**STAFF REPORT**  
**KETCHUM PLANNING AND ZONING COMMISSION**  
**SPECIAL MEETING OF DECEMBER 20, 2022**

**PROJECT:** The 208 Condos

**FILE NUMBER:** P22-035 and P22-035A

**APPLICATION TYPE:** Final Design Review and Subdivision – Condominium Preliminary Plat

Figure 2: Proposed Transformer Location.

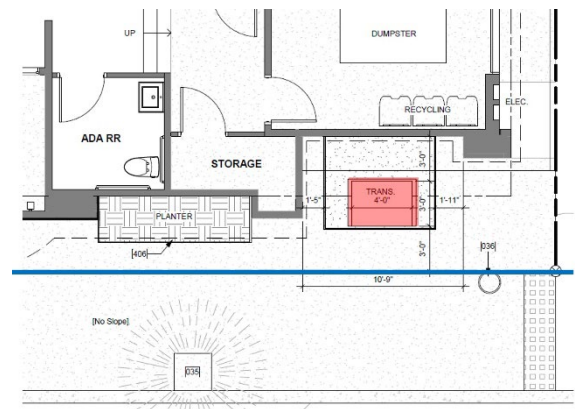
Staff is not supportive of the current location as it does not meet the criteria outlined above specific to screening. Staff also believes the location to be contradictory to the placement of transformers in recent projects within the downtown that have effectively screened transformers. Many projects place this equipment within the rear of the building, opposite pedestrian walkways, and concealed by the building or other substantial screening. Approval of this location would be a departure from what many projects in the community core have designed to and accommodated. The currently proposed location is an improvement from the initial application submittal; however, staff does not believe the placement and screening to be sufficient.

- Evaluate the configuration of ground floor parking and uses to create an adequate space for the transformer in the rear of the property along the northern property boundary
- Screen the transformer with landscaping that will soften the aesthetic of the transformer and adequately screen the equipment year-round. Staff recommends shrubs rather than tall grasses as the grasses are cut down during the winter and will expose the equipment.

Figure 3: Initial and Proposed Transformer Locations

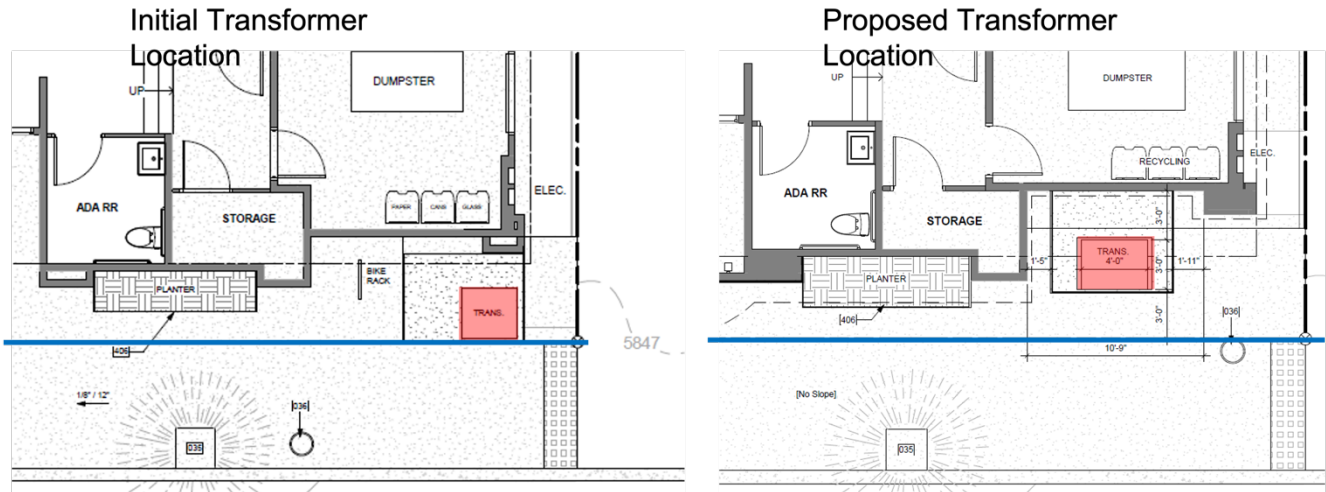
Staff believes the current location is preferable to the initial application, however, the transformer will still be visible by the public at all times of year due to the proximity to the public sidewalk. Staff also has concerns about the metal screening. This screening is seen in other areas of downtown with little practical success. Metal paneling is prone to freezing in the wintertime, causing Idaho Power to break the panels to get access to transformers. Often, repair of the screens by the property management or homeowner's association takes an extended period of time resulting in either no screening, or broken screening that may obstruct alleys or sidewalks.

Figure 4: Proposed Screening of Transformer

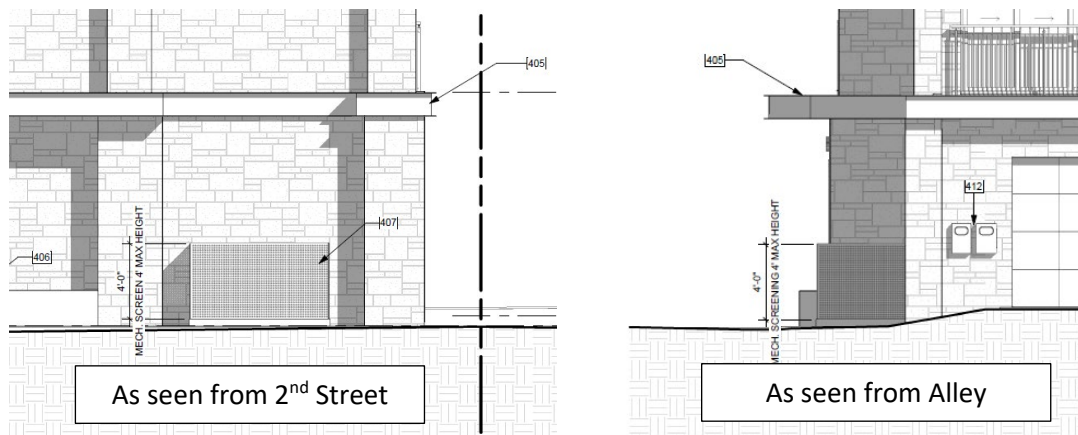
Staff believes that consistent application of the design review criteria is important as the city has made positive progress in the placement of equipment over the past couple of years from previous practice. If allowed to place the transformer in the proposed location, the project is setting an example that would be considered

Figure 6: 2nd Street Facade (elevation)

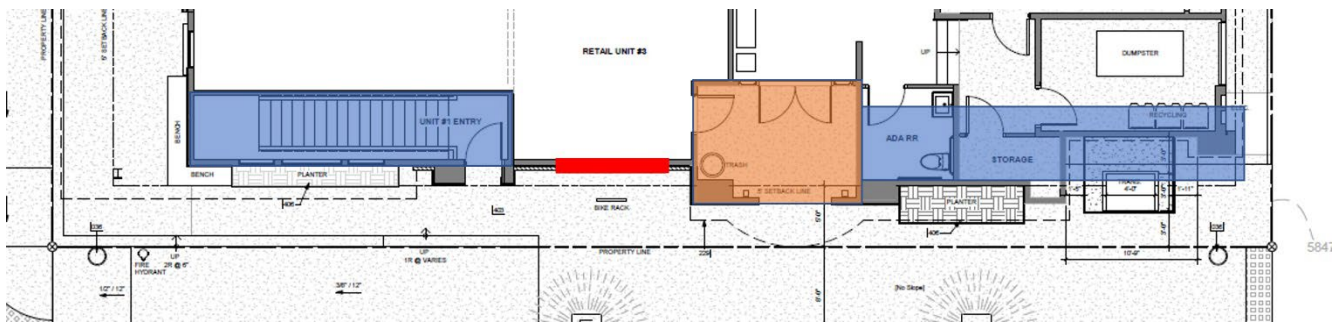
The blue shading notates the stairwell to the basement on the corner and the back of house uses along the façade toward the alley. The orange notes the recessed entry to the building which includes a side entrance to the retail space and the primary entrance for the upper-level residential uses. The red line notates the portion of the façade with direct visibility into the retail space. The intent of the design review criteria is to ensure activation of the street by providing interest for pedestrians. Retail uses rely heavily on “window shopping” potential, which is not supported by the placement of the stairwell in its currently location. Staff recommended the applicant review alternative placement of the stairwell; however the applicant team

represents this is the best location for the purpose of bringing in natural light into the basement unit. The applicant also represents a desire to create a prominent entrance to the upper floor residential units that sets this portion of the building apart from the other uses.

Although staff understands these desires, staff believes the placement of these features diminishes the activation of the street and closes the building off from the pedestrian realm. Staff recommends the applicant consider the following alternatives:

- Relocate the stairwell to the basement residential unit to allow for full visibility of the retail space.
- Reduce the size of the recessed entry to allow for the relocation of the retail entrance to be placed directly onto 2<sup>nd</sup> Street.
